SITE S-92

A PLAT OF SITE S-92, CRYSTAL PARK SUBDIVISION NO. 2, A PORTION OF THE SOUTHEAST ONE-QUARTER (SE1/4) OF SECTION 8, TOWNSHIP 14 SOUTH, RANGE 67 WEST OF THE SIXTH PRINCIPAL MERIDIAN, COUNTY OF EL PASO, STATE OF COLORADO

Plat Drawings_V1_Redlines.pdf Markup Summary

SHEET 1 OF 2

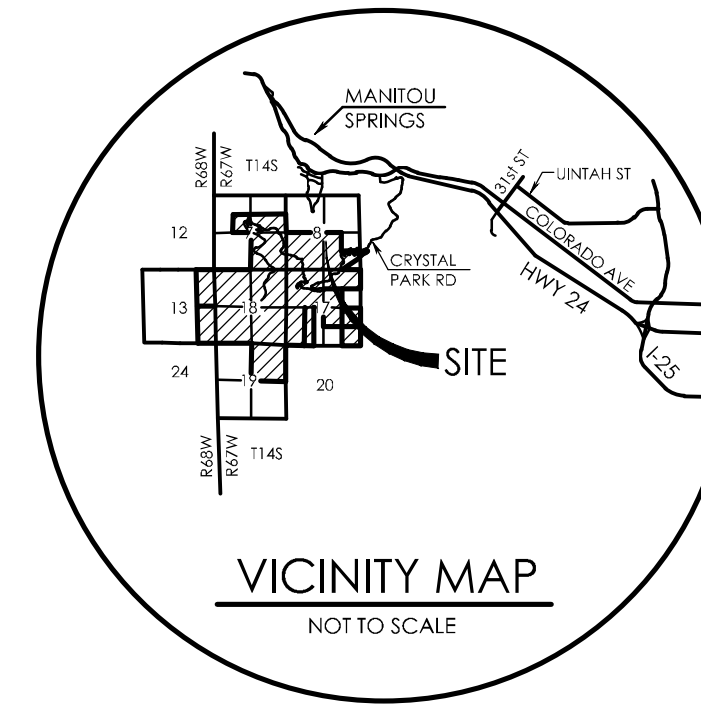
Revise to "El Paso County Planning and Community Development Department"

Please refer to below comment on later note and revise accordingly

Please white-out the clouded notes per other CP plats processed earlier this year and previous email correspondence with Chuck Crum, MVE, and PCD staff in February 2021. Please write over the white-out portions "see page 2/2 for add'l notes" and provide appropriate notes on page 2 of this plat document per snip below:

Add PCD File SF21-01

NOTES (CONTINUED FROM SHEET 1 OF 2)

THE FOLLOWING REPORTS HAVE BEEN SUBMITTED AND ARE ON FILE WITH EL PASO COUNTY PLANNING AND COMMUNITY DEVELOPMENT DEPARTMENT: WATER RESOURCES, SEWERAGE, SOILS & GEOLOGICAL. WATER RESOURCES WERE EVALUATED DURING FINAL PLAT FOR CRYSTAL PARK SUBDIVISION NO. 2. SOIL & GEOLOGY REPORT WILL NOT BE SUBMITTED UNTIL SITE PLAN STAGE.

WATER QUALITY, QUANTITY, AND DEPENDABILITY DETERMINED SUFFICIENT WITH SF-93-002 (RESOLUTION NO. 93-337)
